ADDENDUM NO. 4

CONTRACT NO. 17-529

**PUMPING STATION REHABILITATION
CROTONVILLE PUMPING STATION
OSSINING SANITARY SEWER DISTRICT
OSSINING, NEW YORK**

**CROTON POINT LANDFILL
GENERAL LOCATION PLAN**

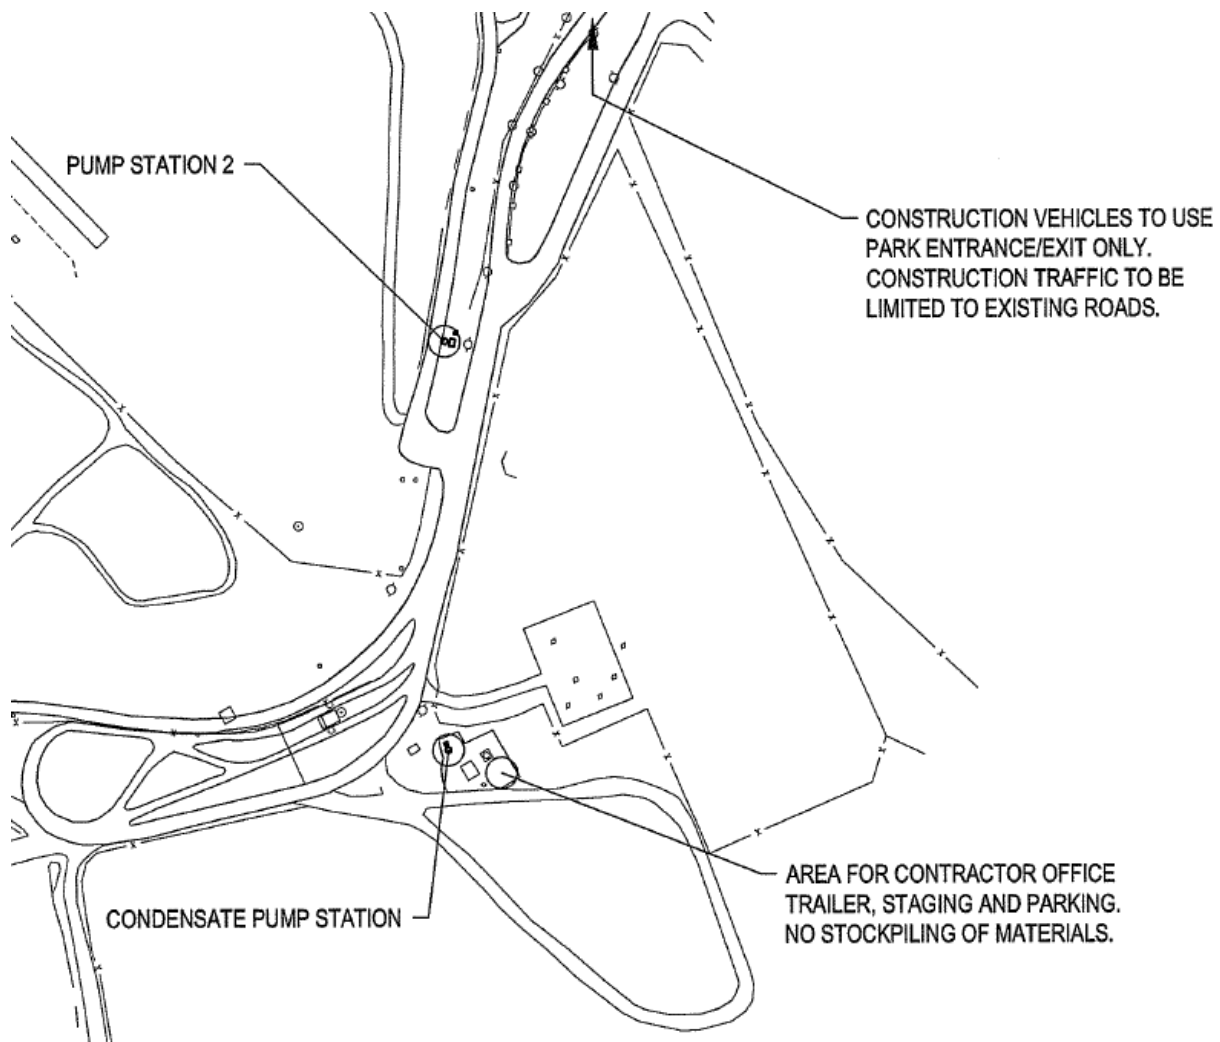
Question 112: Addendum #2 indicates that the County will provide space at the Croton Point Landfill for the contractor's use. Please provide a plan view of this area, showing the exact location and size of the area, electrical services available, and restoration requirements.

Response: *See Attached General Location Plan and Addendum No.2 for restoration requirements. The County does not intend to provide a temporary electrical service at this location.*
